RESPONSES TO QUESTIONS BY NSW COASTAL PANEL

RE: REPAIRS TO SEAWALL AT 28 & 28A CHILDE ST, BELONGIL
REF: DOC17/82318

REPAIRS TO SEAWALL AT 28 & 28A CHILDE ST, BELONGIL

X-SECTION B (PRESENT)

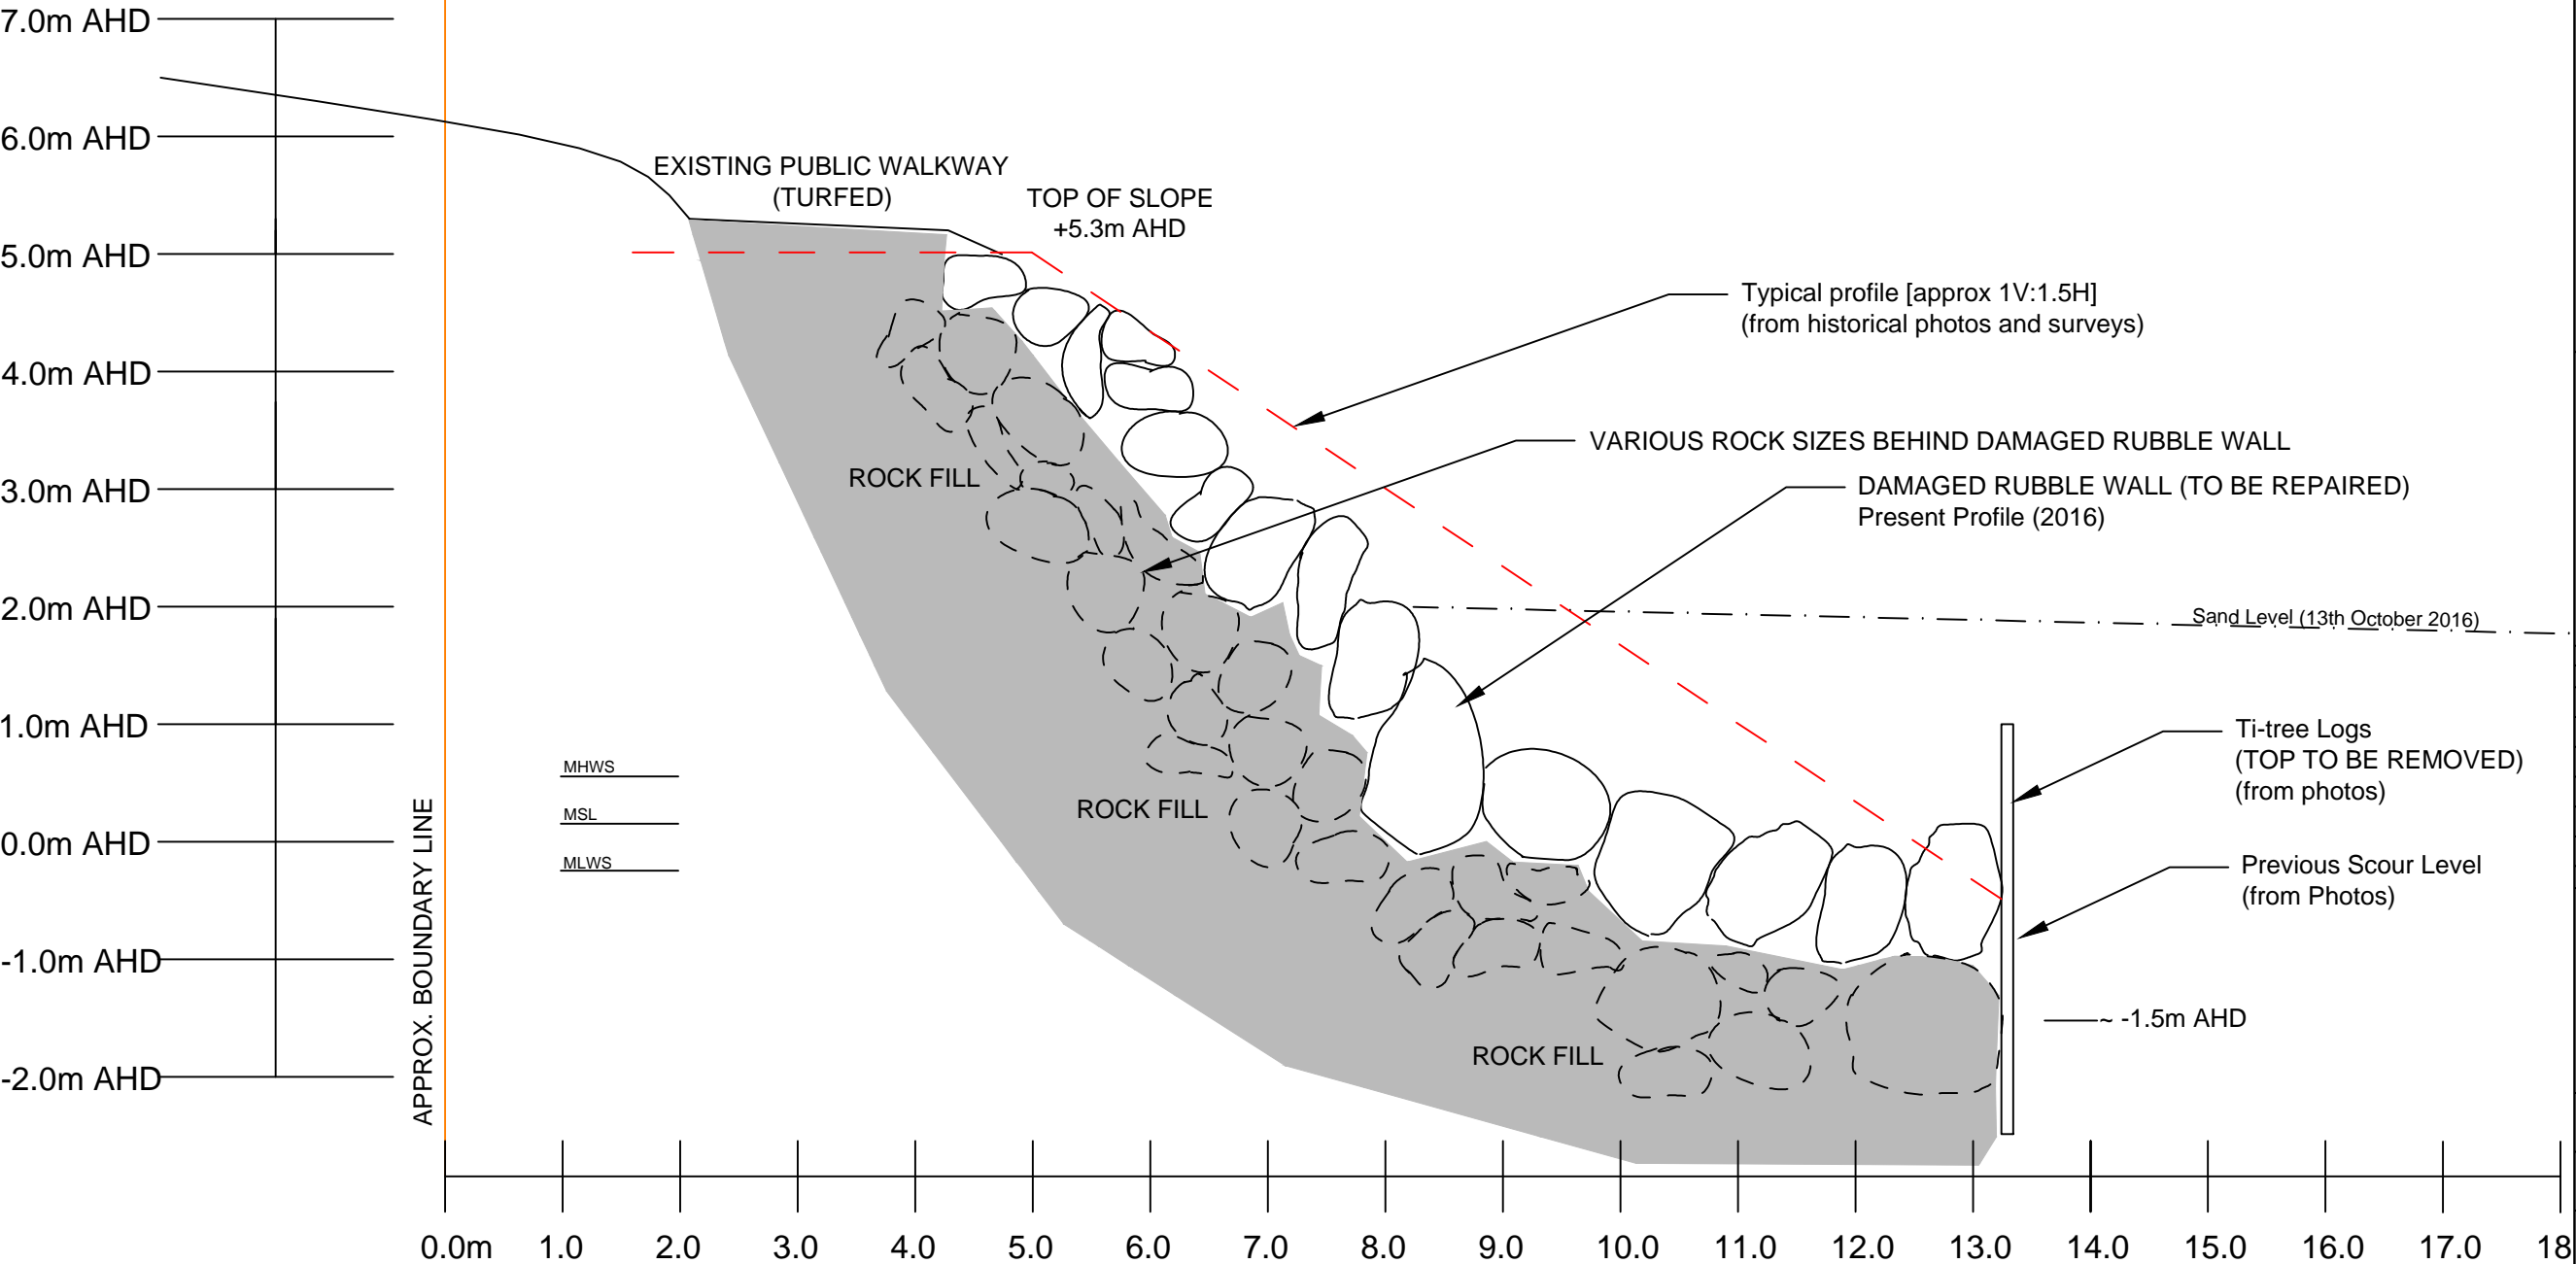
g. Toe scour levels;

Response: The existing wall have largely accommodated toe scour over its life. The typical scour levels are shown in the x-sections in drawings 003 and 005 (Attachment A).

TYPICAL REPAIR PROFILE B

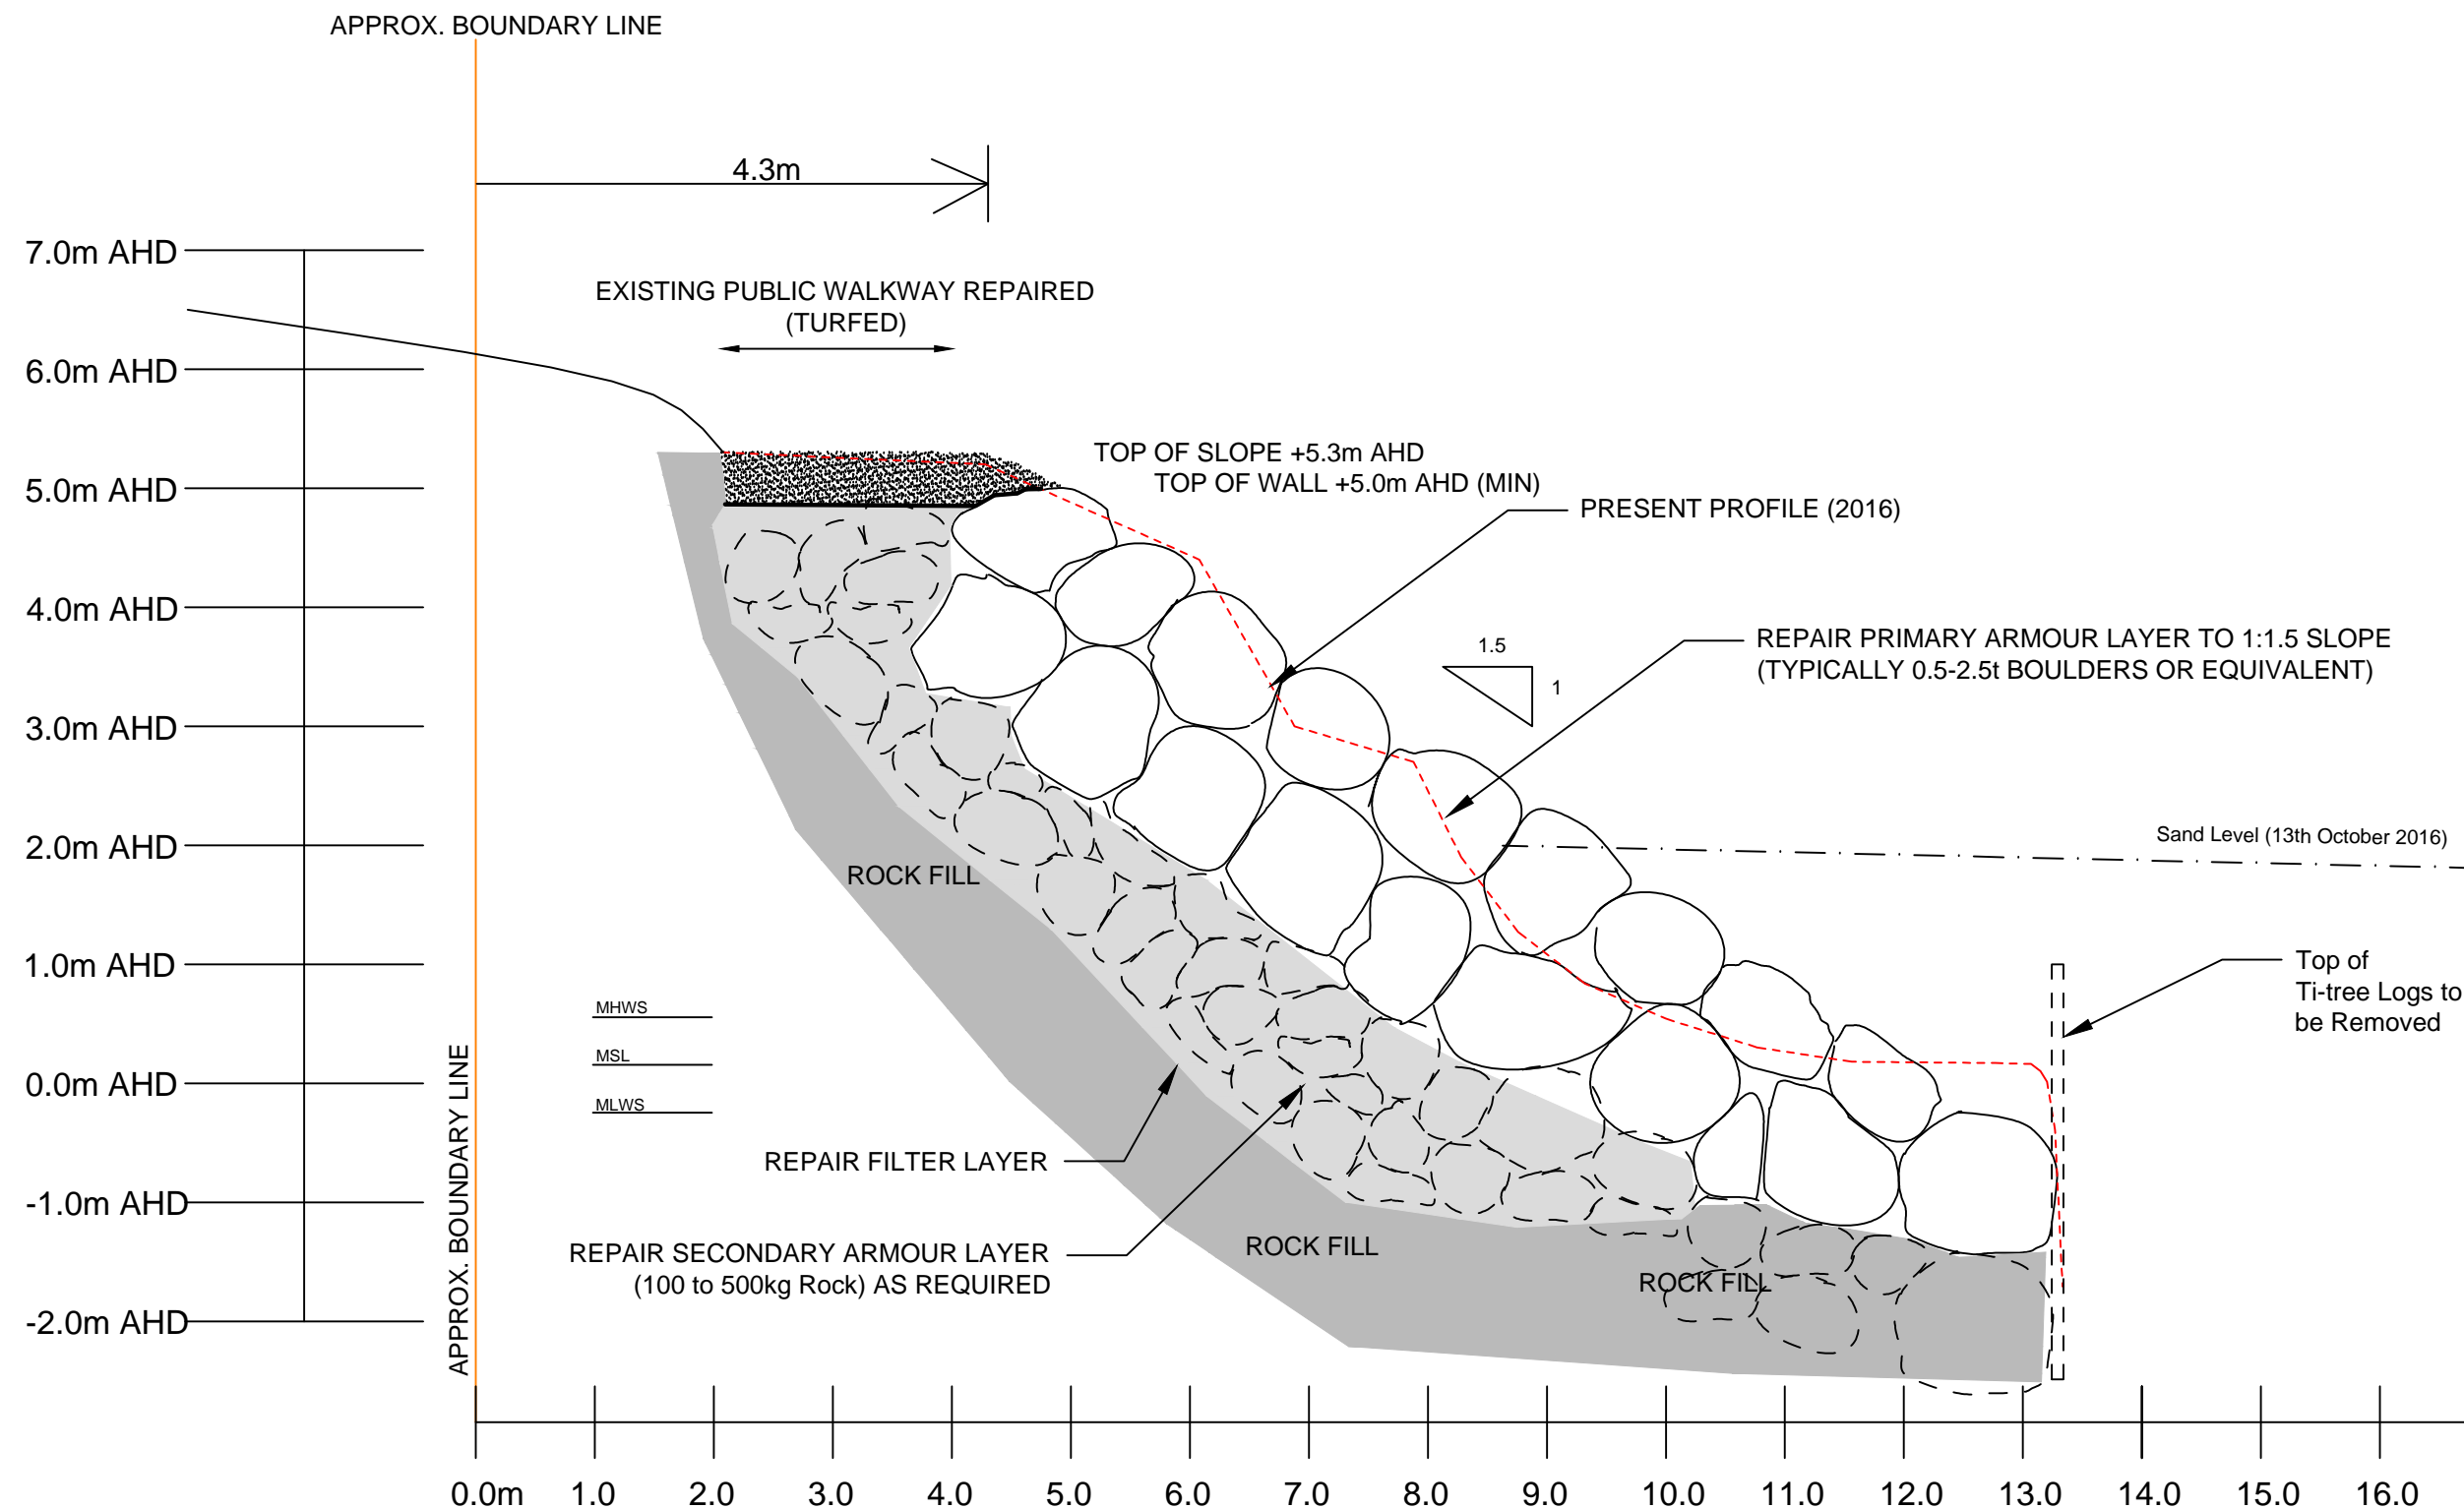
h. Crest levels;

Response: The existing crest levels have been adequate and the repaired crest levels are shown in the x-sections in drawings (Attachment A).
